PROJECT
RYLANDS BUILDING, MANCHESTER

TITLE
COMPARISON PLAN FIFTH FLOOR

JOB No	DWG No	REV
1526	AL[05]4218	*

ISSUE FOR
PLANNING DOCUMENT

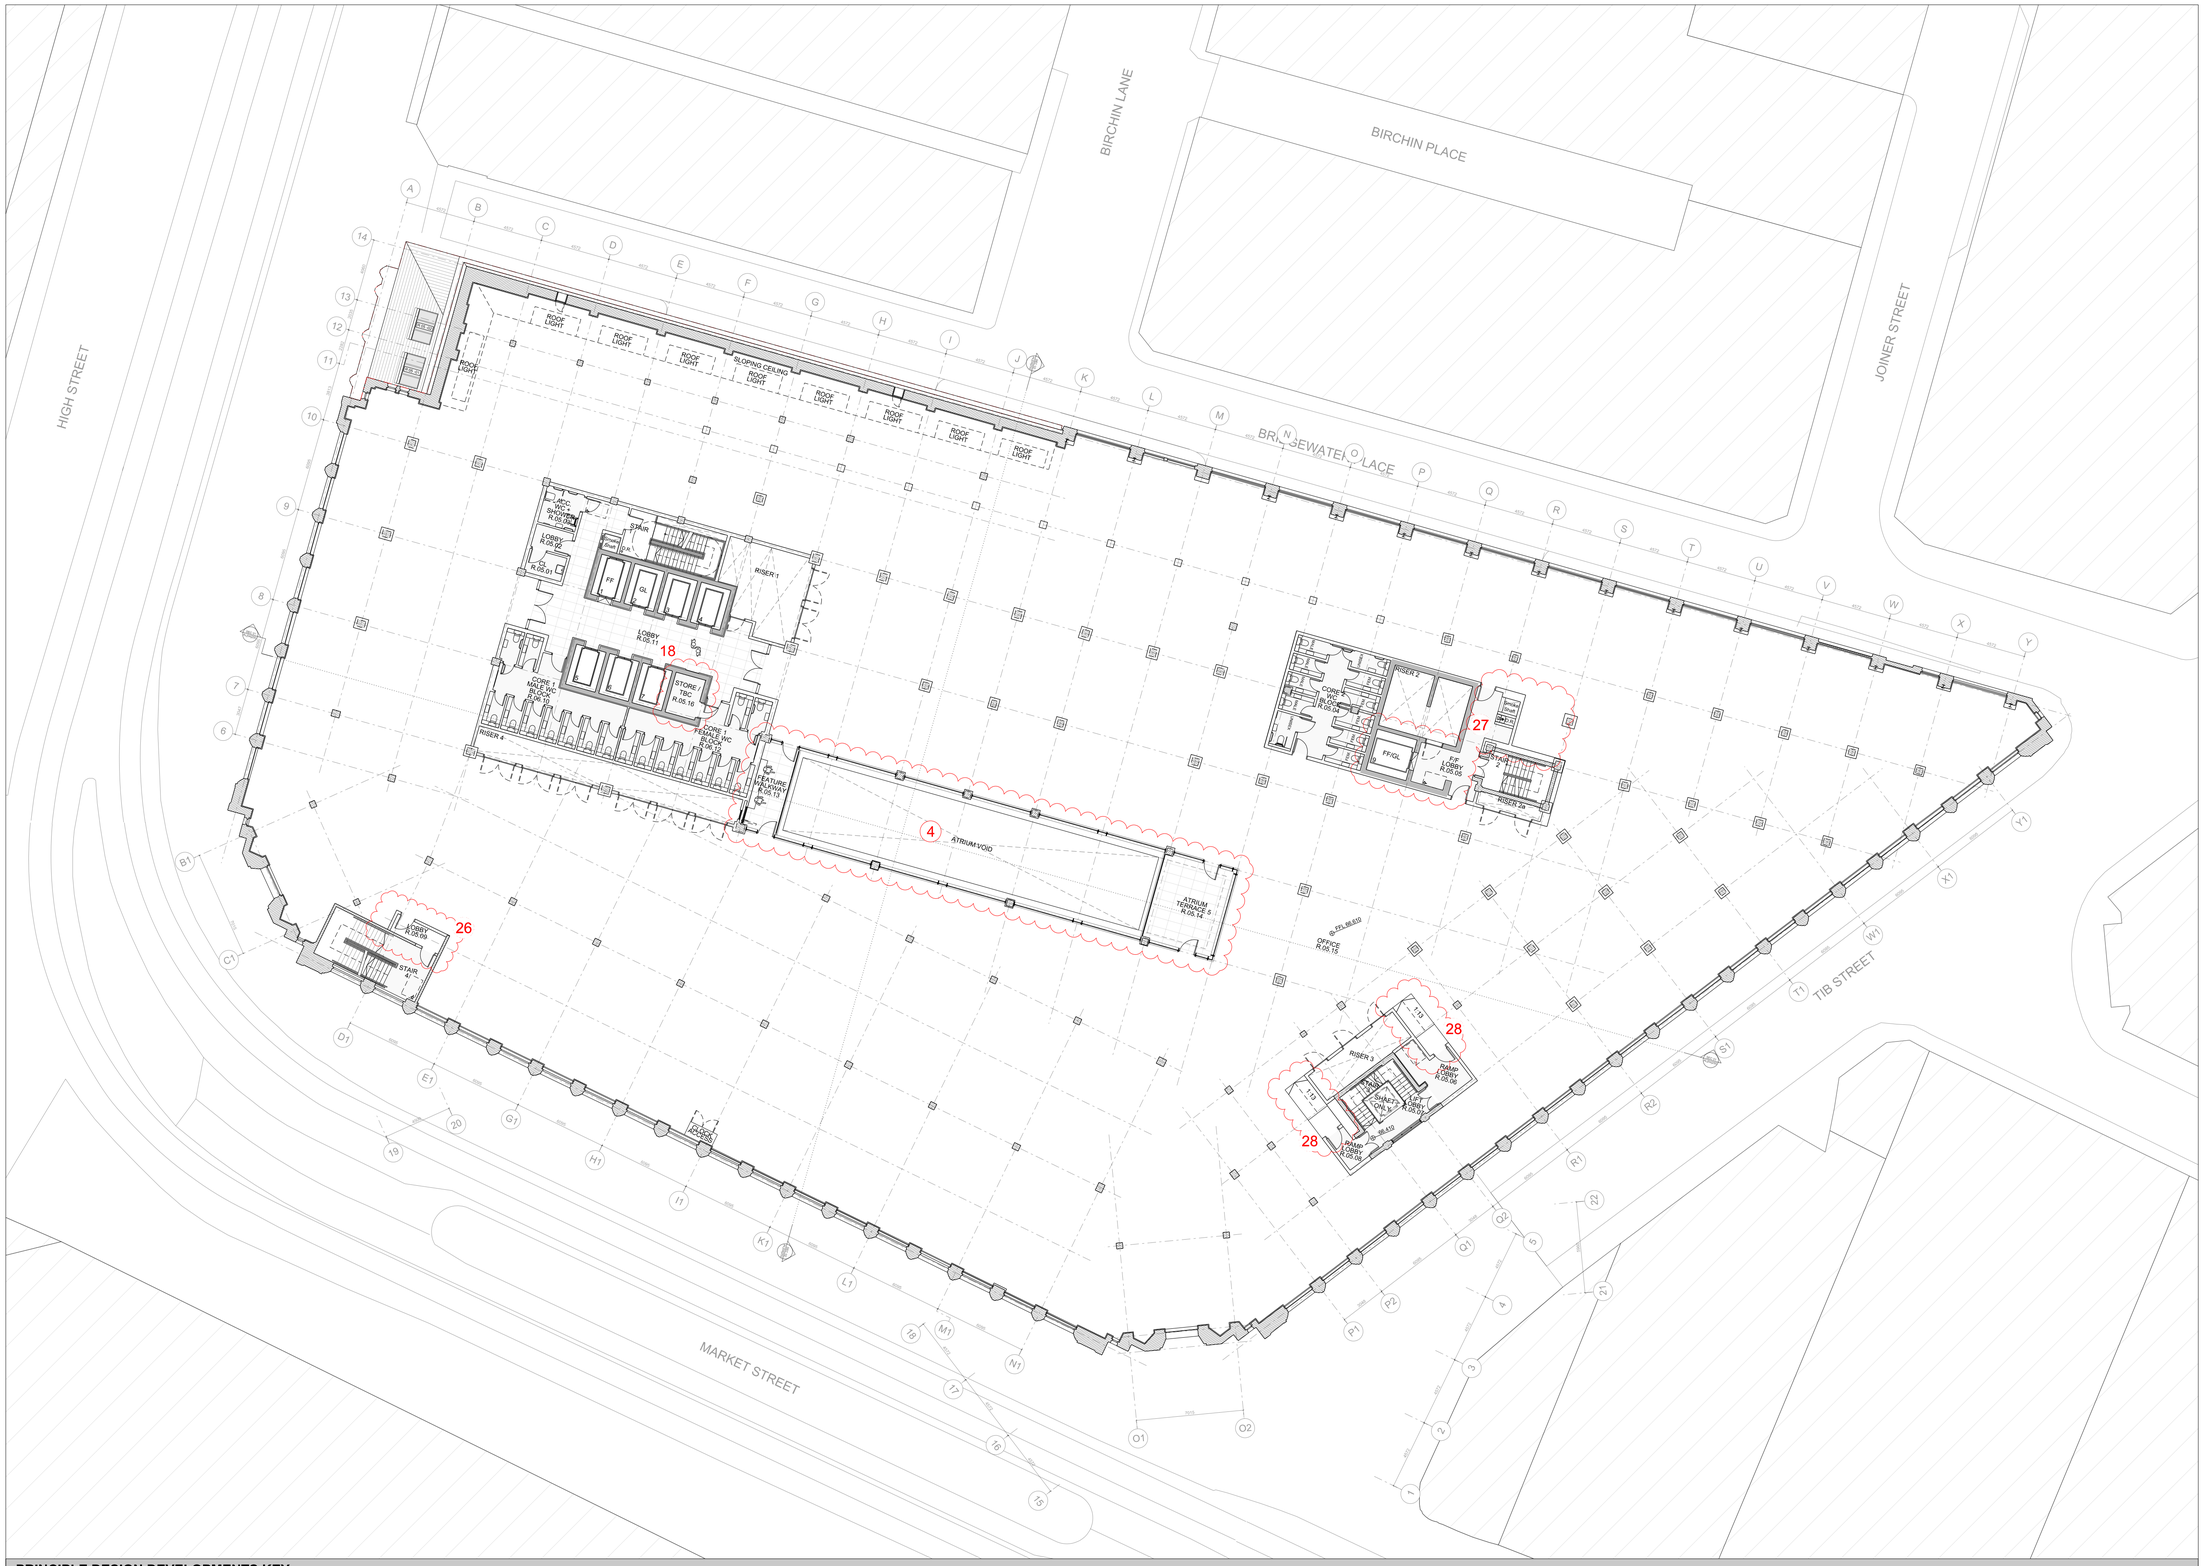
1. Double-mullions & Parallel Opening Vents omitted from extension elevations
2. Saw-tooth roof profiles reduced in number & length. Sawtooth structures to carry PV panels only, thermal envelope now at roof slab level.

3. Core 2 lift overrun height lowered within Roof Plant enclosure due to VRF MEP strategy.
4. Glazing sections to Atrium simplified.
5. Terrace 7A omitted. New back-painted glass screen to accommodate new VRF MEP servicing strategy at existing roof level. PPC vent louvres to lid, & to base of West elev, concealed behind main stone parapet.

6. New Market Hall Unit & revised Office Foyer at Ground Floor Level
7. Lower floors replanned (see notes on General Arrangement plan drawings).
8. Overall height remains unchanged from the consented scheme.

9. Roof-plant enclosure reduced in width & lengthened to GL. H to accom. VRF MEP strategy. PPC vent louvres to base of South & North elevs concealed by sawtooths.

10. Double-mullions omitted from Shop-front glazing
11. New fire exits required to Shopfronts for Market Hall use
12. New Market Hall entrance door arrangements

13. Updated Cycle-store entrance and exit arrangements
14. Back-painted glass in glazed facade system to match main facade system - Profiled metal cladding omitted.

15. Lift overrun wall widened to conceal adjacent plant.
16. Protected Lobby update.
17. Store area adjusted.
18. Lift 8 omitted. Void/Store/tbc
19. Drop shaft relocated.

20. Facilities Management & General Back of House areas updated to accommodate Market Hall.
21. Plant and bin store arrangement updated to accommodate Market Hall.

22. Lobby arrangement to increase locker provision within changing
23. Cycle lift & ramp omitted for new cycle-stair, reducing structural impact
24. Continuity of EXTG Floor area (hatched) subject to investigation - possibly ground bearing slab at high level

25. Updated lobby & stair entrance preserving more of existing building fabric.
26. Lobby arrangement to increase in area.
27. Core 2 Lift functions & service levels rationalised for efficiency

28. Ramp external to Stair 3 lobby
29. Equipment Room provided.
30. Rooflights rationalised into singular rooflight
31. Cleaning facilities provision updated.

32. WC added.
33. Extg balconies refurbed for reuse.
34. Winter Garden omitted.
35. External fabric amendment to accommodate existing structure.
36. Existing doorway retained, new door fitted to match new adjacent.

37. Security bollards to Bridgewater Place entrance.
38. Bird & batbox proposed locations included.
39. Partition line moved to increase commercial space.

40. Green roof to flat roof of L7 link.
41. Ducting terminations in aesthetically coordinated metal sheathing.
42. Renewables omitted @ L7 roof.
43. Horizontal plant-screen fins omitted.

44. Overrun of Lift 10 removed.
